# UNITED STATES PATENT AND TRADEMARK OFFICE

<b>Office Action Summary</b>	<b>Application No.</b>	<b>Applicant(s)</b>	
	09/110,694	MILLS, RANDELL L.	
	<b>Examiner</b>	<b>Art Unit</b>	
	Stephen J. Kalafut	1745

# **Response to Request for Continuing Examination SN 09/513,768**

The following is a response to Applicant's arguments against the key analysis provided in the Appendix attached to the May 7 Advisory Action.

**Fig.1 (from ref.[5])**

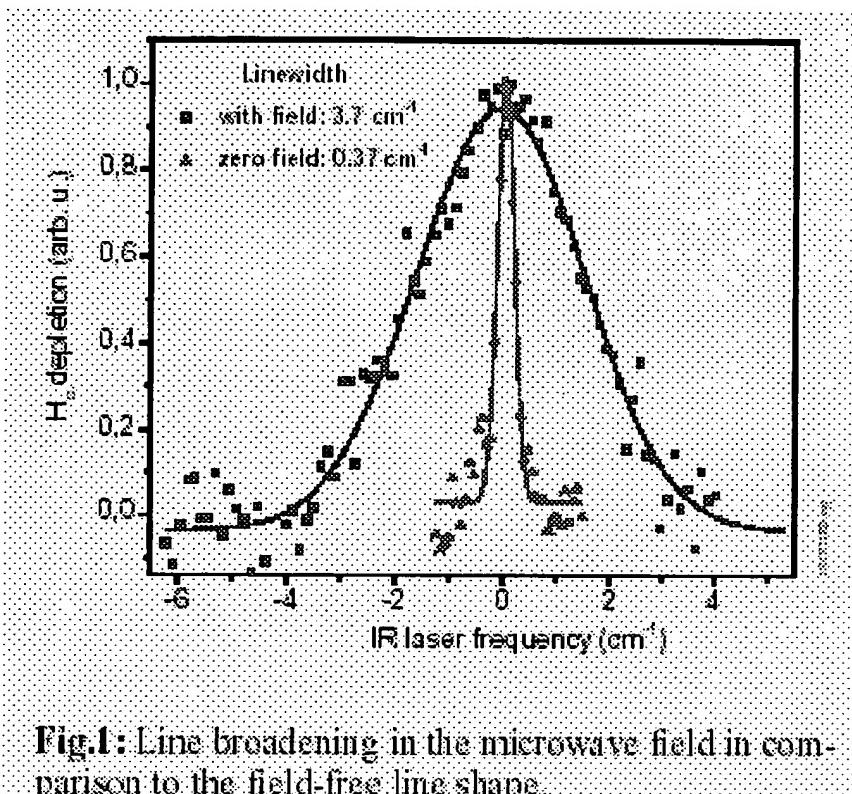
Secondly, and most importantly, anomalous hydrogen line broadening is not at all an evidence for the existence of hydrino, because it is well known in the art that such a broadening may be caused by many other conventional mechanisms, such as microwave plasma effects, the latter having not been considered by Applicant. Instead, such an effect has been sofar ignored or dismissed by Applicant without any valid reason. The measured excessive line-width shown in Applicant's Fig.6 of ref.[6], i.e., 0.27 nm, is about the same magnitude as what is measured by other authors, e.g., ref.[5] cited in the May 7 Appendix, here reproduced in Fig.1 below.

As shown in Fig.[1], the anomalous line width of 0.16 nm, measured in a microwave discharge similar to Applicant's under the same gas mixture and pressure range, is about 10 times the Doppler width, and has been attributed to microwave plasma effects. Applicant's previous criticism on this reference [5] is unjustified. The paper was a conference publication posted by a research group from the University of Essen, Germany. It is not a lone-standing unrefereed paper as alleged by Applicant, but instead, supported by a large number of experimental and theoretical works, as listed at the end of the paper. It would have been extremely doubtful to one of ordinary skill in the art if any cause other than the RF/microwave field itself should be held responsible for an effect that is only and exclusively observed in RF/microwave plasmas.

Thus, Applicant's "excessive *line broadening*" is not at all an evidence for Applicant's hypothetical "hydrino", but rather, a conventional effect that has been already observed by other authors, as evidenced in Fig.1. Such a high frequency Stark effect has never been considered in any of Applicant's numerous reports on "anomalous" or "excessive" line broadening. Instead, Applicant always assumes that Doppler effect were the main cause, as clearly stated on pp. 6-7 of Applicant's Appendix attached to the RCE. The assumption of Doppler effect as a main mechanism for Applicant's line broadening has been known as incorrect for RF and microwave plasmas, as discussed above. Applicant's mis-assumption of this line-broadening mechanism automatically disqualifies all Applicant's arguments based on anomalous or excessive line broadening in microwave plasmas.

Applicant's statement on page 6, that "The Examiner does not present any alternative explanation for the cited data", is doubly unpersuasive. Firstly, alternative explanation was readily provided by the result shown in Fig.1, which has been explicitly cited in the previous May 7 Appendix [5].
